To: Priscilla Tomlinson
From: Garrett Leque, LG; Terry McPhetridge, LG, LHG
Date: March 9, 2023; revised May 16, 2023
File: 25806-001-00
Subject: Precision Engineering Phase 2 Work Plan Addendum

This memorandum presents the Phase 2 Work Plan Addendum for field investigation activities proposed at the former Precision Engineering site in Seattle, Washington. This is an addendum to the document “Remedial Investigation Work Plan, Precision Engineering Site,” dated March 31, 2022 (2022 Work Plan). Refer to the Work Plan for additional information for the site.

Table 1
Draft Summary of Phase 2 Proposed Activities
Precision Engineering, Inc.
Seattle, Washington

Figure 1

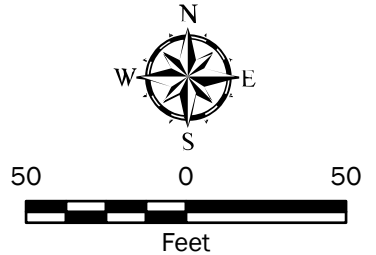
The Phase 2 proposed investigation activities are based on the Phase 1 investigation results and discussions with Ecology regarding the Phase 1 results and remaining data gaps at the site. Proposed investigation locations are shown in Figure 1 that include the following.

- Four direct-push boring locations (SB34 through SB37).
- Five new monitoring wells (MW19 through MW23).
- Four additional hand auger locations (HA26 through HA29).
- Four surface water (ditch) sampling locations (SW1 through SW4).

9	LDW Pathway analysis	As previously demonstrated by multiple investigations and groundwater modeling, it is unlikely for this site to contribute contaminants to the LDW. Phase 2 will continue to investigate potential pathways by sampling stormwater in the ditch, and with installation of a monitoring well in the southeast portion of the site as discussed above. Additionally, six four direct push borings (SB-34 through SB-3937) are proposed in the ditch (as access allows).	SB-34 through SB-3937	Agreed on SB-34 through -39. Note that only five locations are shown on the map. The surface water samples and the new wells discussed on line 12 ("Groundwater data gaps") will also evaluate potential transport to the LDW.	Agreed. We meant to propose 5 direct-push borings as shown on map. Furthermore, it is apparent that MW-19 can take the place of the easternmost direct push boring after discussing the location of MW-19 with Ecology on February 16, 2023. Therefore, we are proposing 4 direct-push borings, SB-34 through SB-37, as shown on Figure 1.
